Comments on

THE PROPOSED RESTORATION AND MAINTENANCE OF THE BLUE STONE QUARRY WALL, ROBBEN ISLAND

Revised Maintenance Management Plan May 2021

Peter Barham, University of Bristol, UK on behalf of the Earthwatch South African Penguins Project

Figure 2 photograph taken at the top of the south revetment wall in early June 2021 overlaid with a sketch showing the route penguins returning from the sea take to reach the foot of the wall and then climb over it. The damaged (undercut) part of this wall can be seen top centre.

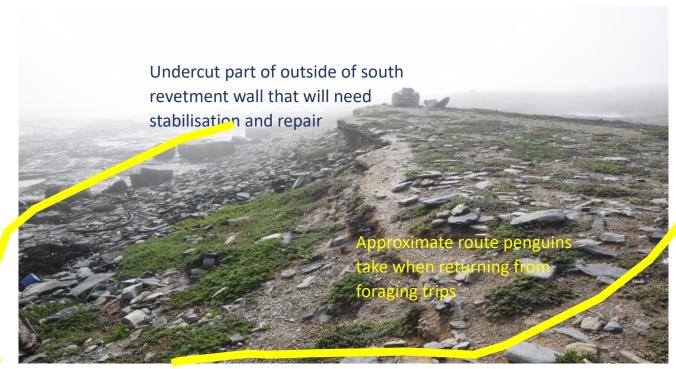
If one looks at the outside of the revetment wall below and just to the east of the point at which penguins climb the wall to get into the quarry, it is very clear that storm damage has seriously undercut the structure (see figure 2) and that some considerable reconstruction will be required to stabilise and repair the wall here. I cannot see how that work can be carried out without interdicting the current route the penguins take to climb the wall for the duration of the work. By the time the work reaches this area all the work to the north will have been completed so there will no longer be any easy route to the south over the original now collapsed wall. Once work starts along this section, the danger of a collapse of the overhang to workers at the base of the wall will almost certainly mean that safety and health considerations will force the partial demolition of this section and hence remove at a stroke the penguins only remaining route ashore.

I do not have any solution to this issue. But it may be possible to develop plans that allow the work to be phased to allow that there is always an easy route for the birds to cross the quarry wall (e.g. creating a ramp up over the rebuilt outer wall) and encouraging birds to use that route by the judicious use of fences, etc. If that can be done then once the penguins do actually take up the alternative route – and only once they have done so – it could be possible to work on the section of wall where the penguins currently cross.

A clear plan agreed with all parties for how to carry out works on the South revetment wall without preventing penguins from crossing through the quarry.
